**1970 - 1973 Corvette: Service Bulletin:
Overheating - 454 Cu.In. Engine with Air
Conditioning**

73-T-28

Subject: ENGINE OVERHEAT - 1970-1973
CORVETTES WITH 454 CU. IN.
ENGINES AND AIR CONDITIONING

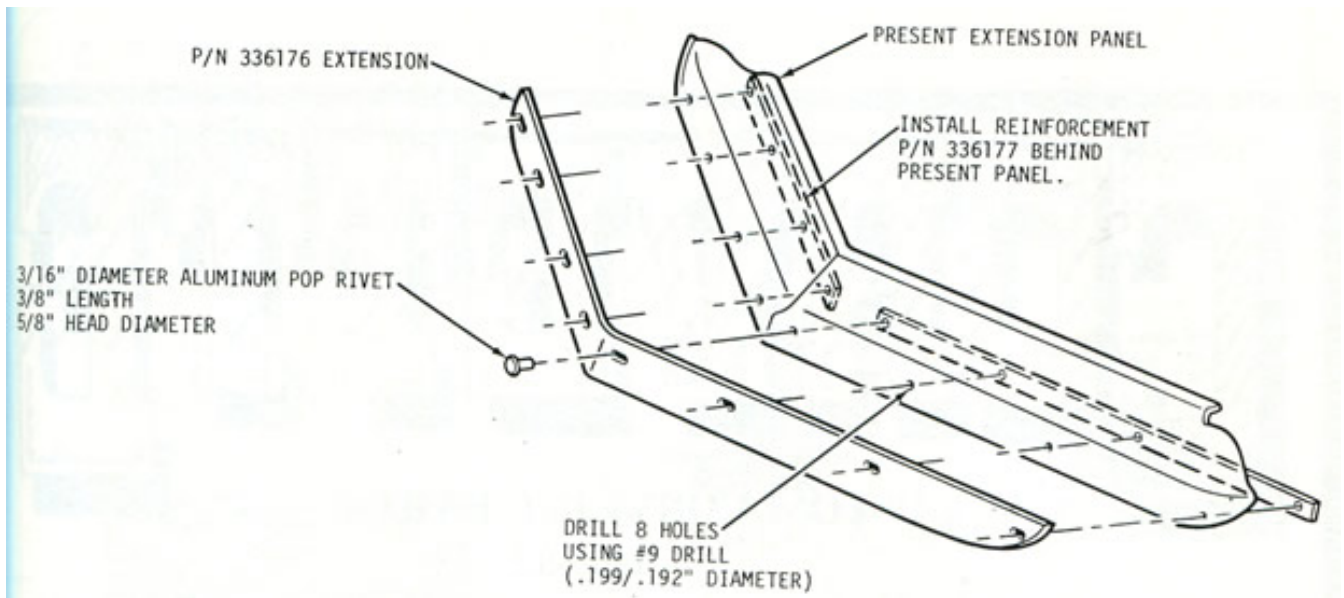
To improve low speed cooling, an additional grille panel lower extension was installed in 1973 Corvettes produced after Vehicle Identification Number 1Z37Z3S410722. This extension, Part Number 336176, may be installed as illustrated on page 2 of this bulletin on early 1973 Corvettes only.
